PROPOSED TECHNICAL  
SPECIFICATION CHANGES

**DISCUSSION AND  
SIGNIFICANT HAZARDS  
CONSIDERATION EVALUATION**

**TECHNICAL SPECIFICATION CHANGE REQUEST**  
**SURRY POWER STATION - UNITS 1 AND 2**  
**24-HOUR SERVICE WATER ACTION STATEMENT**  
**TEMPORARY SERVICE WATER SUPPLY LINE**

FIGURE 2 - SYSTEM CONFIGURATION FOR STEP 4

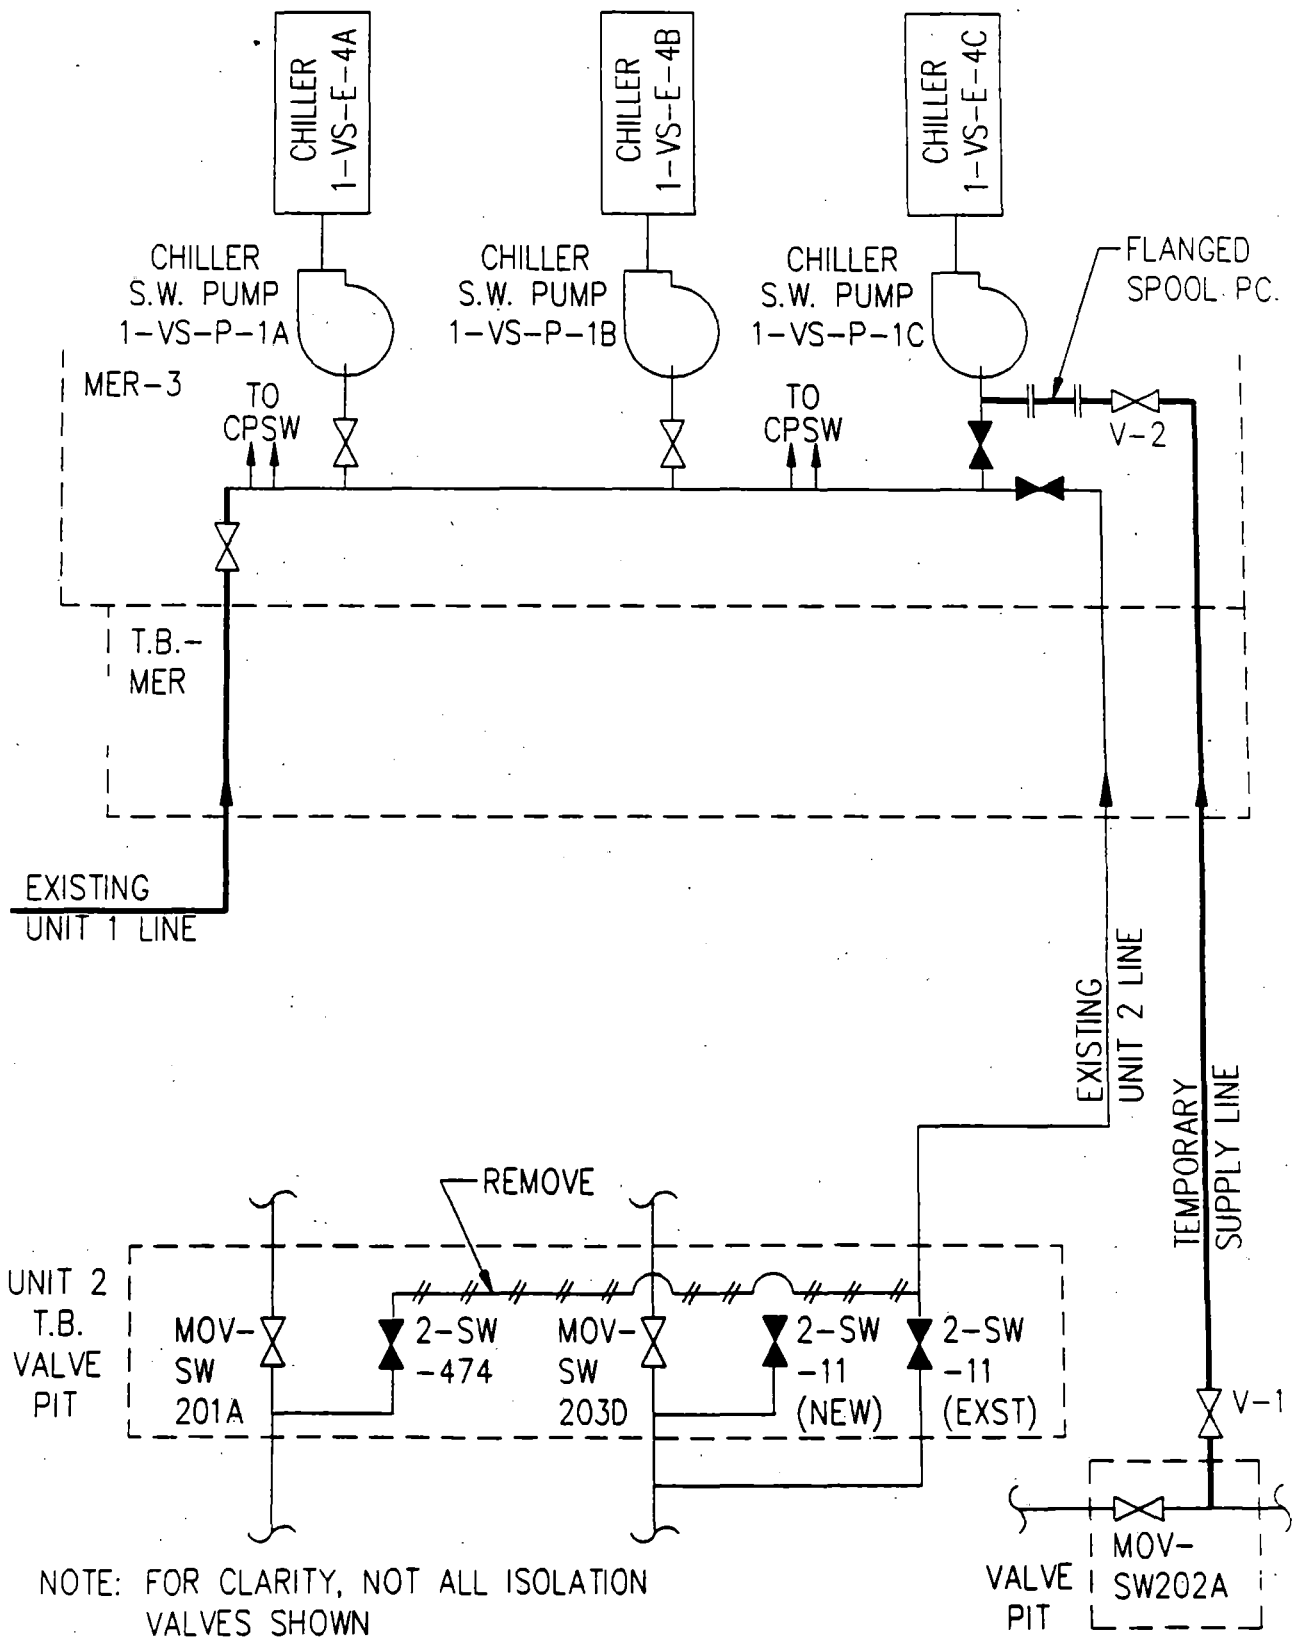
4. Remove existing Unit 2 line from service and enter 24-hour action statement. Eliminate the cross connect line in the Unit 2 SW valve pit. This allows the two Unit 2 sources to be isolated independently. Reinstate the Unit 2 line (via 2-SW-11) and exit the 24-hour action statement.

FIGURE 3 - SYSTEM CONFIGURATION AFTER STEP 5

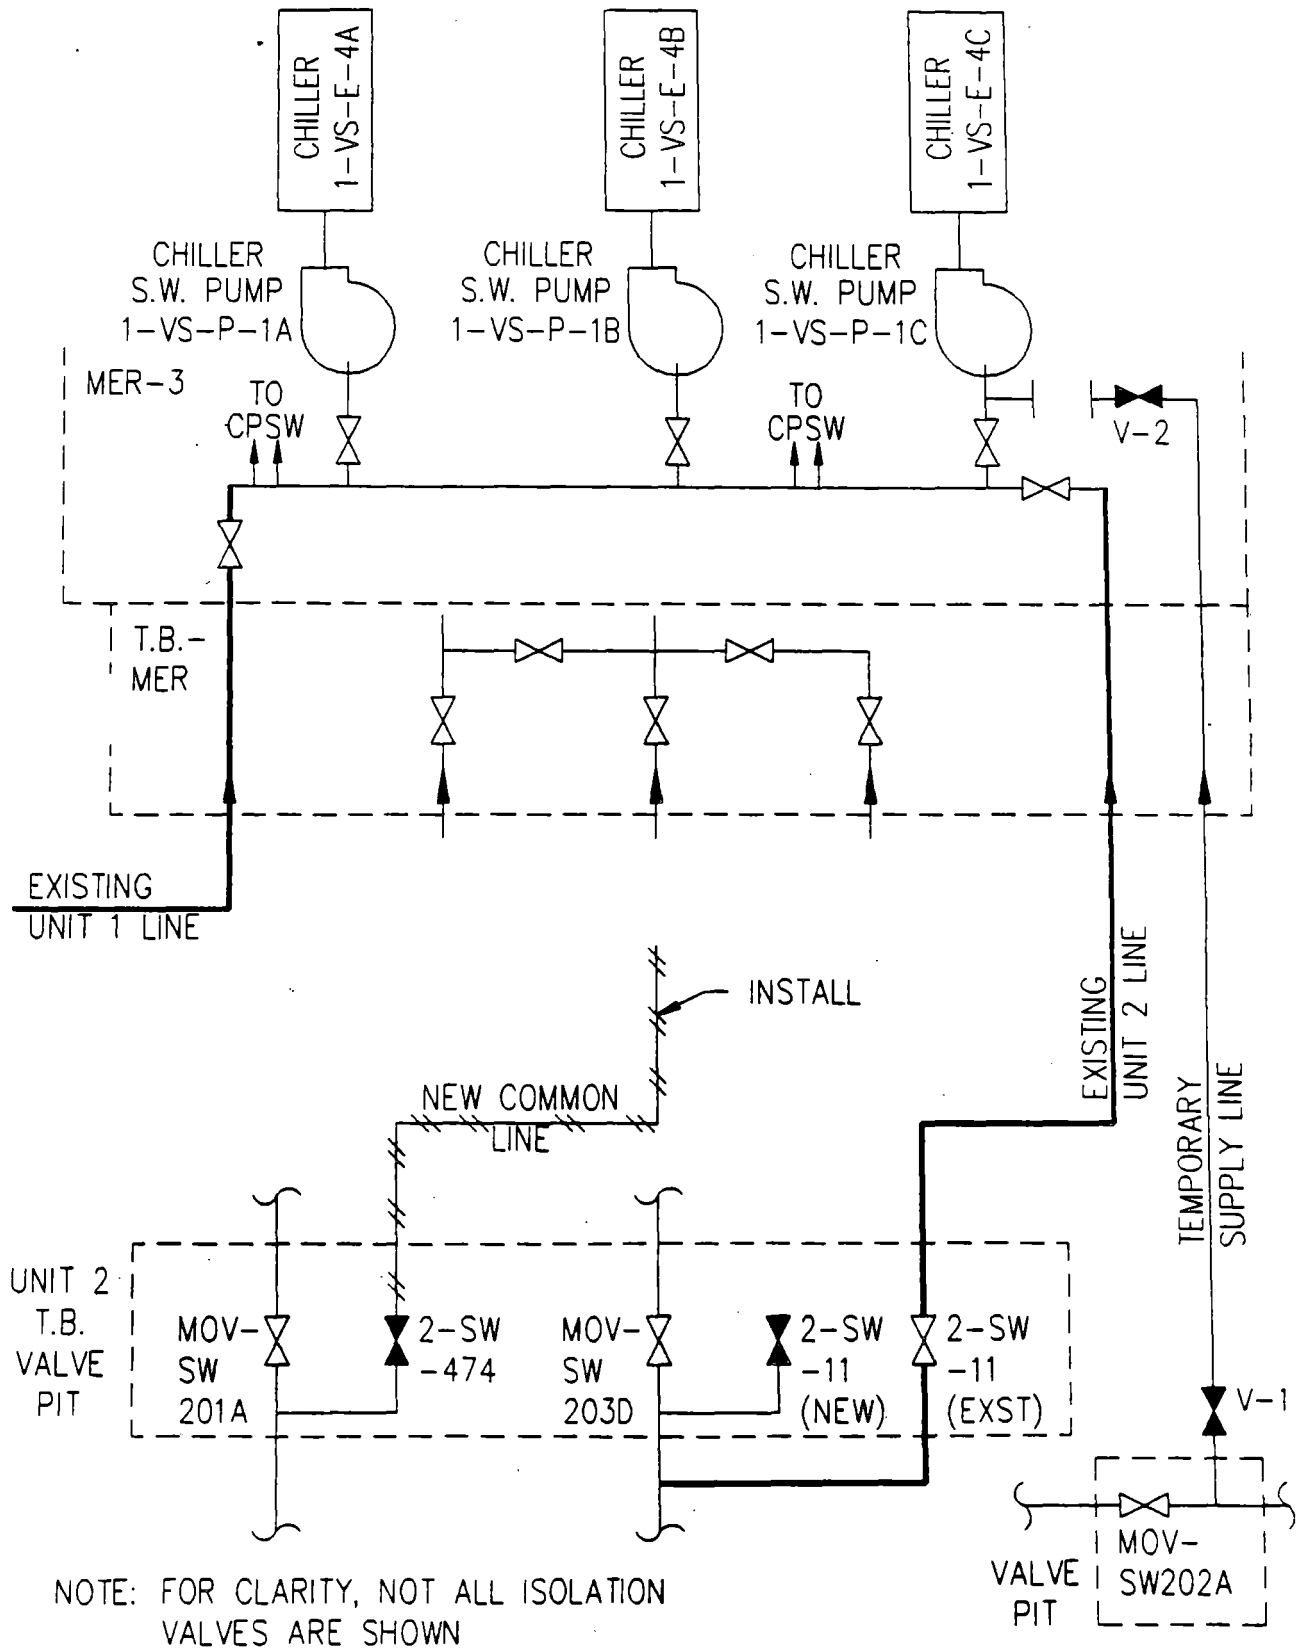
5. Install new common line in trench and tie-in new 8" common line to the new common line source (valve 2-SW-474) at Unit 2 SW valve pit and a valve manifold which was already installed (see Figure 3). During line installation, the existing operating line will be protected by backfill and a steel plate.

FIGURE 4 - SYSTEM CONFIGURATION FOR STEP 6

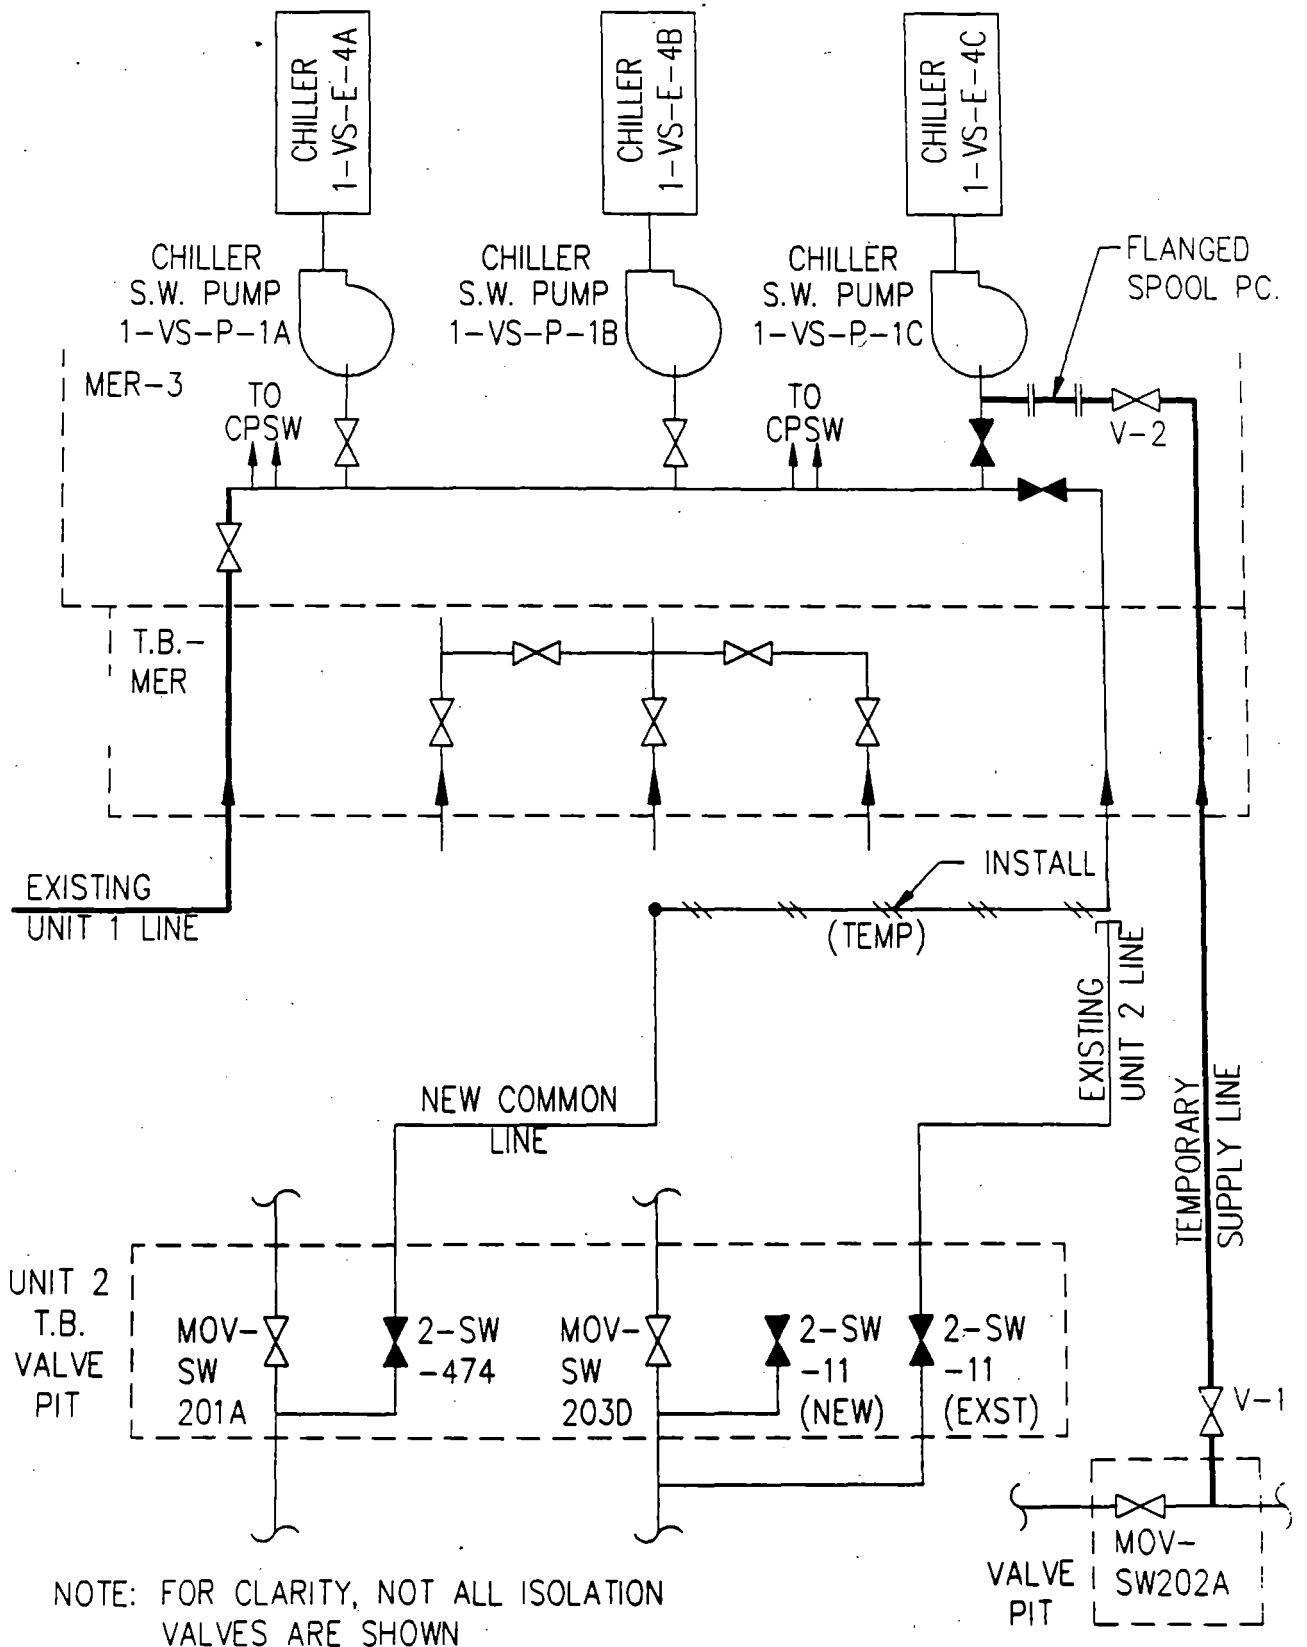
6. Remove Unit 2 line from service and enter the 24-hour action statement. Install a temporary jumper between new 8" common line and existing Unit 2 fiberglass line in the trench. The Unit 2 alternate flow path now consists partially of 8" copper-nickel and partially 6" fiberglass. Exit the 24-hour action statement.

FIGURE 5 - SYSTEM CONFIGURATION FOR STEP 7

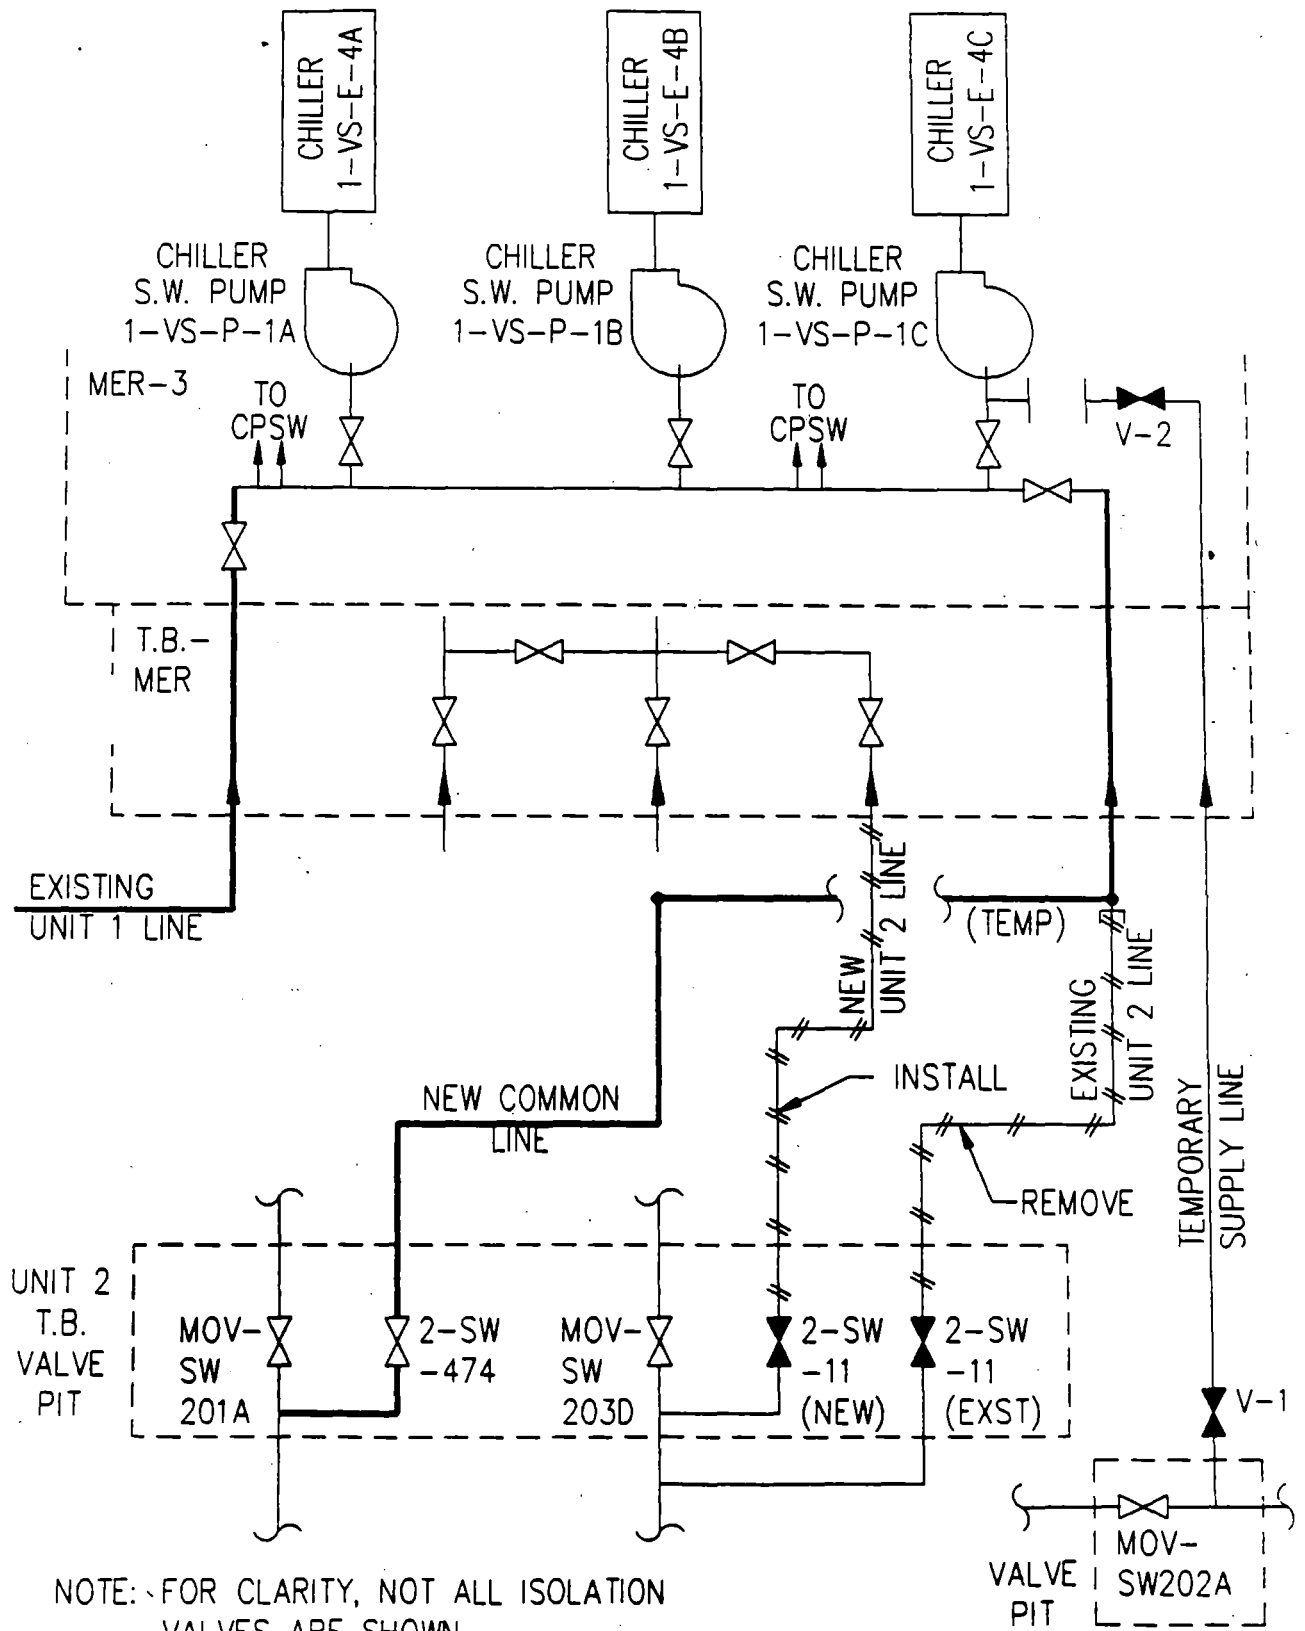
7. Install new 8" Unit 2 line in trench, at the TB-MER wall and tie-in new 8" Unit 2 line to the new Unit 2 8-inch source (8" valve 2-SW-11) at the Unit 2 SW valve pit. The original 6 inch valve 2-SW-11 is blanked off.

FIGURE 6 - SYSTEM CONFIGURATION FOR STEP 8

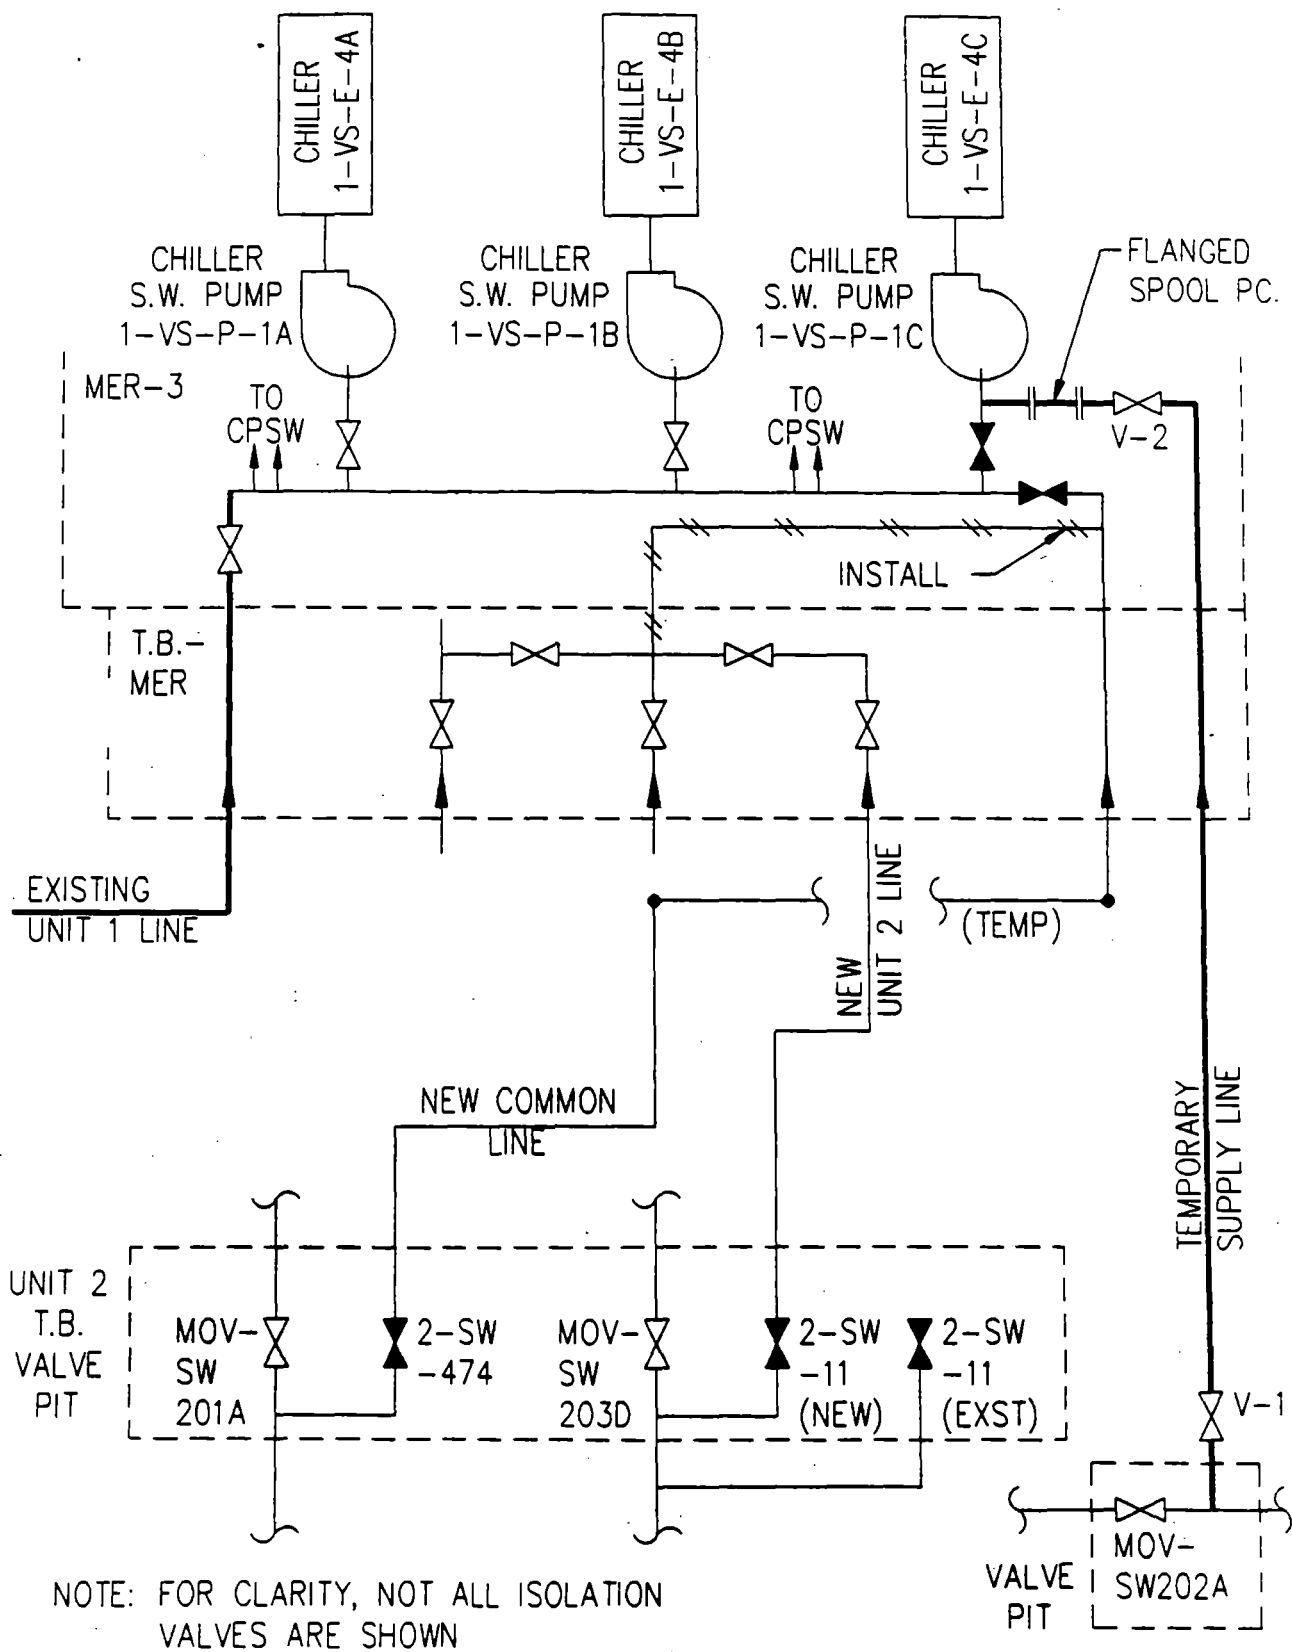
8. Remove Unit 2 alternate line from service and enter 24-hour action statement. Make tie-in through new core drill in the TB-MER/MER-

3 wall. Shift flow from the alternate Unit 2 line to the new Unit 2 line. Exit the 24-hour action statement.
